## Grid India (Detailed Procedures for Security Constrained Unit Commitment (SCUC), Unit Shut Down (USD), and Security Constrained Economic Despatch (SCED) at Regional Level), 2023 [Draft]

Grid-India notified "Detailed Procedures for Security Constrained Unit Commitment (SCUC), Unit Shut Down (USD), and Security Constrained Economic Despatch (SCED) at Regional Level" on 07th September, 2023. The key highlights of the draft are mentioned below:

## **CER Opinions**

Figure 2: Increased generation costs to maintain reserves under SCUC

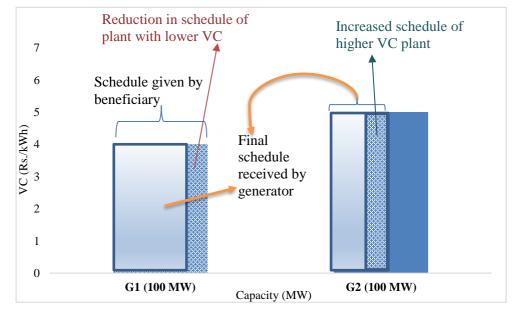
8. Change in the overall economics of the power procurement: As per Clause 6.17 of the proposed draft, "*Typically, the net sum of generation schedules under SCUC head would be zero, as only reserves are being created through SCUC and extra energy is not being scheduled.*" As illustrated in the following figure 1, two generators committed under SCUC (say, G1 = 100 MW and G2 = 100 MW) have same capacity but different variable costs (say, Rs. 4/kWh and Rs.5/ kWh respectively). Generator G1 received 100% schedule (100 MW) from its respective beneficiary while G2 received 40% schedule (40 MW) i.e. below minimum turndown level. In order to create the reserves and prevent G2 to go under shutdown, the NLDC increased its schedule up to 55% under SCUC-up (55 MW) and reduced the schedule of G1 to 85% under SCUC-down (85 MW). Thus, the overall generation schedule remained equivalent to the original schedule (140 MW). While cost of power procurement for the beneficiaries does not seem to increase as they would be billed as per their schedule, the economics of power procurement for the subsequent blocks that cross over to the next day

(due to min up or min down time constraints) would be affected. Increase in schedule of higher VC plant and reduction in schedule of lower VC plant will **increase the overall system cost for the current blocks in D day**. The incremental cost of the same would be met through the pool account.

Due to minimum up/ down time constraints, the high-cost generator, which was revived, would be treated as 'must run' plant (by the system operator) for the minimum number of up/ down time hours that may spill over to the next day. Are these plants to be treated as 'must run' by the beneficiaries while preparing schedule for the 'constrained' hours pilling over to the next day? If so, the power procurement cost for the beneficiaries would effectively increase for the next (D+1) day.
